Broadcast Products Technical Bulletin 20-2010-016R

DATE: **June 27, 2011**SUBJECT: **LOOSE V SHOE ASSEMBLY OR WEDGE SCREWS**

**Figure 1****MODIFICATION PROCEDURE****Loose V Shoe (D) Assembly Screws**

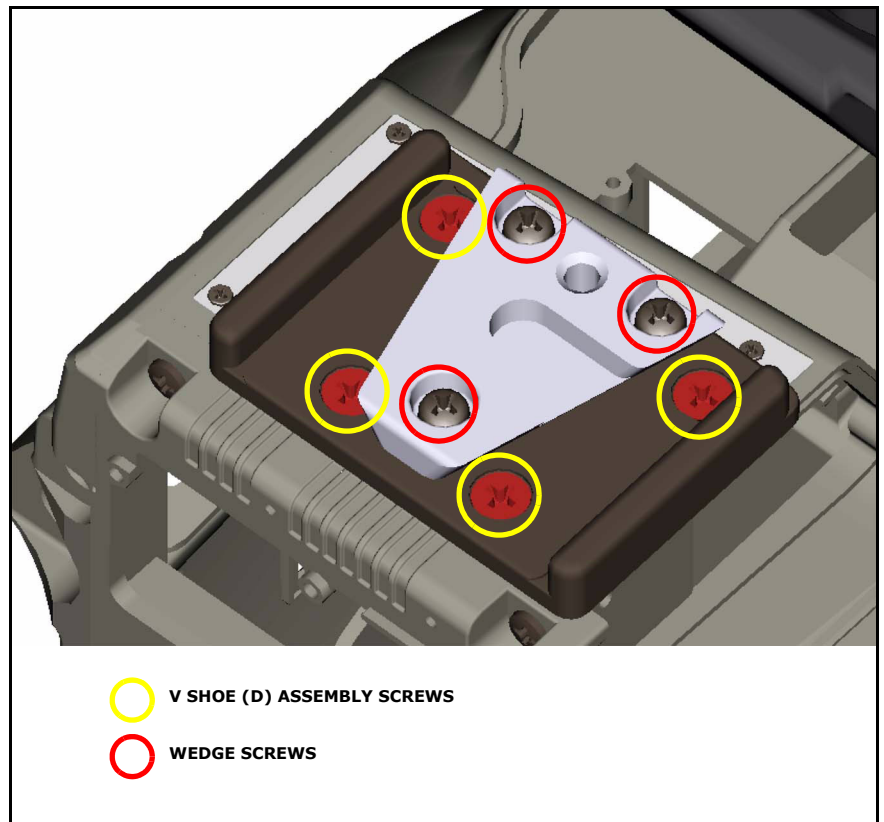
On rare occasions, the four screws securing the V shoe (D) assembly or the three screws securing the wedge may become loose from repeatedly installing the camera to the tripod adapter. (See Figure 1.)

If the ALOK +K4×8 screws affixing the V shoe (D) assembly to the chassis are loose, tighten all four screws with a tightening torque of 1.8 N·m.

NOTE: The former tightening torque was 1.4 N·m.

If torque is reduced in only one or two of the three +P4×6 wedge screws or if the torque of all three screws is only slightly reduced and wedge position is NOT displaced:

If the torque of all three +P4×6 wedge screws is significantly reduced and if mechanical play or slippage occurs in the wedge:

CAUTION: The V shoe (D) assembly is mounted in the factory with wedge position adjusted so that the V shoe (D) assembly can be mounted to any VCT. If screws become loose, wedge position may no longer meet specification. If the screws of the displaced wedge are tightened without proper positioning, the V shoe (D) assembly may not be mountable on some VCTs.

1. Apply locking compound (ThreeBond TB-1401B or equivalent) one screw at a time to the tips of all screws and to three or four threads, taking care not to displace wedge position.
2. Tighten all three screws with a tightening torque of 1.6 N·m.

Replace the entire V shoe (D) assembly with a new V shoe (D) assembly (A-8279-993-D), tightening the assembly screws with a tightening torque of 1.8 N·m.
